Work Order ID 93229

Item Name: Replacement Skidtube STD w/ Training Wearplates

DRAWING NO. D3887		TITLE A119 STD SKIDTUBE ASSY		REV. B	DART AEROSPACE LTD ENGINEERING ORDER		D.E.O. NO. D3887-B-1	SHEET NO. SHEET 1 OF 1	SCALE NTS
DRAWN AJS		CHECKED <i>q</i>		MFG. APPR. <i>q</i>		APPROVED <i>q</i>		DE APPR. <i>q</i>	
DATE 12.10.29		DATE 12.10.29		DATE 12.10.30		DATE 12.10.30		DATE 12.10.30

MODIFICATION OF EXISTING DESIGN TO ALLOW INSTALLATION OF CROSSBOLT SPACERS FOR FORWARD GROUND HANDLING EQUIPMENT.

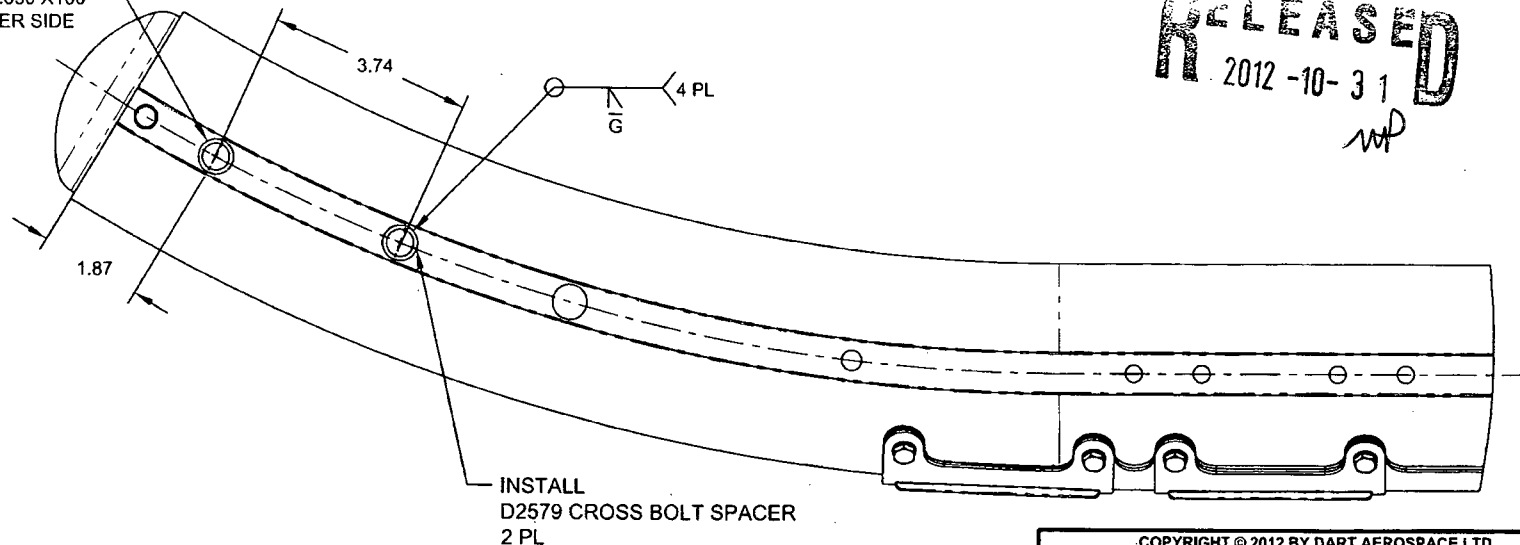
ADD THE FOLLOWING:

10	2	2	2	D2579	CROSS BOLT SPACER
----	---	---	---	-------	-------------------

ADD THE DRILLING DETAIL BELOW TO DRILLING INFORMATION (SHEETS 5 & 6):

ADD CROSSBOLT SPACER INSTALLATION INFORMATION TO -041 THRU -045 (SHEETS 2 - 4):

**FIGURE 1. MODIFIED D119-646-XXX SKIDTUBE**

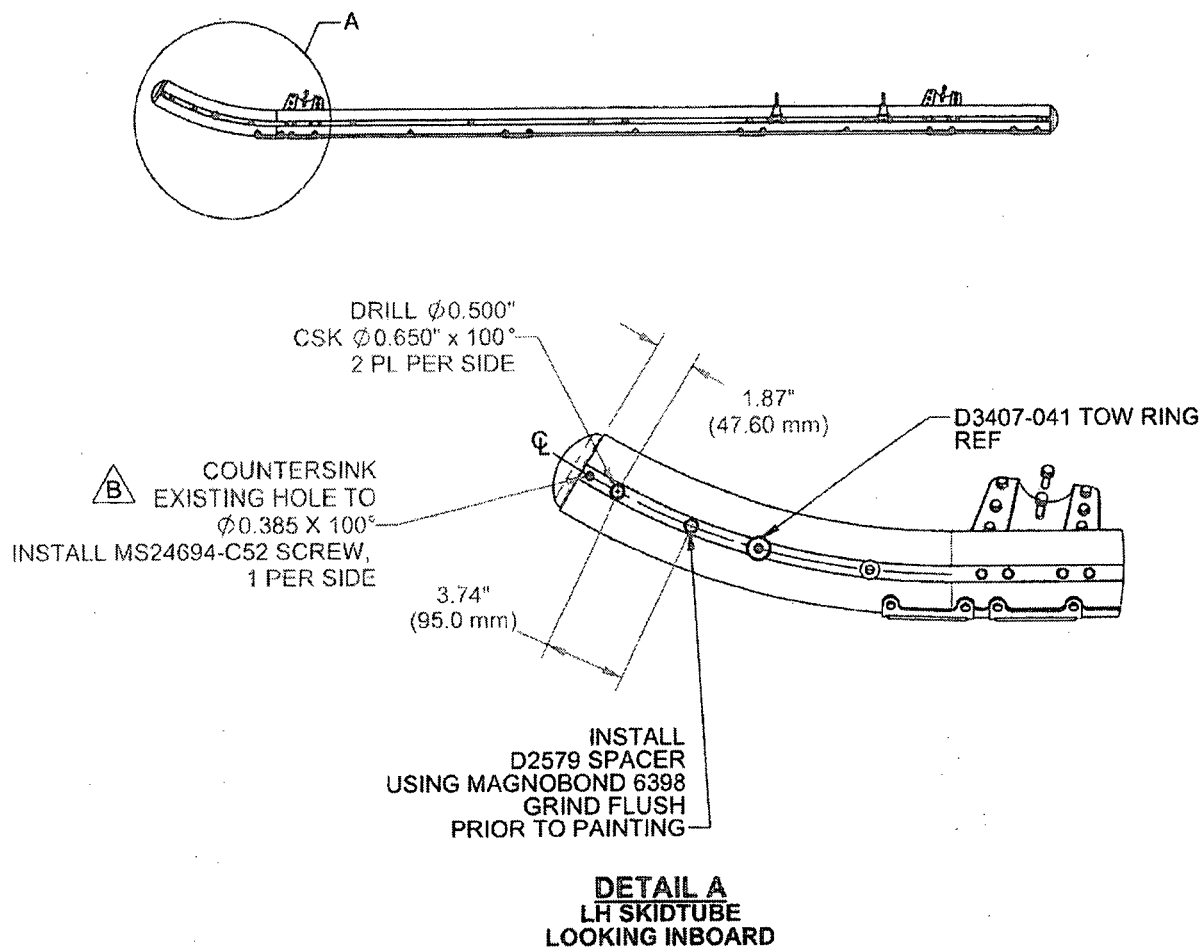
The purpose of this DSI is to provide instructions for customers to modify the forward end of the D119-646-XXX skidtubes using the DSI 9594-011 Kit to make the skidtubes compatible with the Agusta ground handling wheels. One kit modifies 2 skidtubes. After CHG 001, portions of this modification may have been incorporated in production and therefore will not need to be incorporated in the field.

- 2.1 Rotate the D3407-041 Tow Ring to the vertical position as necessary.
- 2.2 Mark holes in the center ridge as shown in Figure 1. Drill through skidtube with Ø0.500" (12.7 mm drill), and countersunk to Ø0.650 x 100°, two places per side.

- 2.3 Remove and discard the hardware retaining the forward Cap. Countersink the existing holes to Ø0.385 x 100°.
- 2.4 Deburr holes. Touch up affected areas with chemical film material (Alodine 1200 or 1201) per MIL-C-5541.

- 2.5 Bond D2579 spacers into the Ø0.500 holes center in the skidtube using Magnobond 6398. Grind flush prior painting as shown in Figure 1.
- 2.6 Apply one coat of MIL-P-85582 or MIL-P-2337 primer and 2-3 coats of MIL-C-83285 polyurethane coat to match original finish.

B	ADD INSTRUCTION TO REMOVE EXISTING CAP MOUNTING HARDWARE AND REPLACE WITH COUNTERSUNK SCREWS	DB	13.02.20
A	NEW ISSUE	RF	12.02.03
REV.	DESCRIPTION	BY	DATE
DESIGN	RF	<b>DART AEROSPACE USA, INC.</b> KENT, WA DRAWING NO. <b>DSI 9594</b> TITLE <b>FWD GROUND HANDLING SPACER KIT</b> SCALE <b>NTS</b> REV. B SHEET 1 OF 2 COPYRIGHT © 2012 BY DART AEROSPACE USA, INC. <small>THIS DOCUMENT IS PRIVATE AND CONFIDENTIAL AND IS SUPPLIED ON THE EXPRESS CONDITION THAT IT IS NOT TO BE USED FOR ANY PURPOSE OR COPIED OR COMMUNICATED TO ANY OTHER PERSON WITHOUT WRITTEN PERMISSION FROM DART AEROSPACE USA, INC.</small>	
DRAWN	DB		
CHECKED	MB		
MFG. APPR.	N/A		
APPROVED			
DE APPR.			
DATE	13.02.20
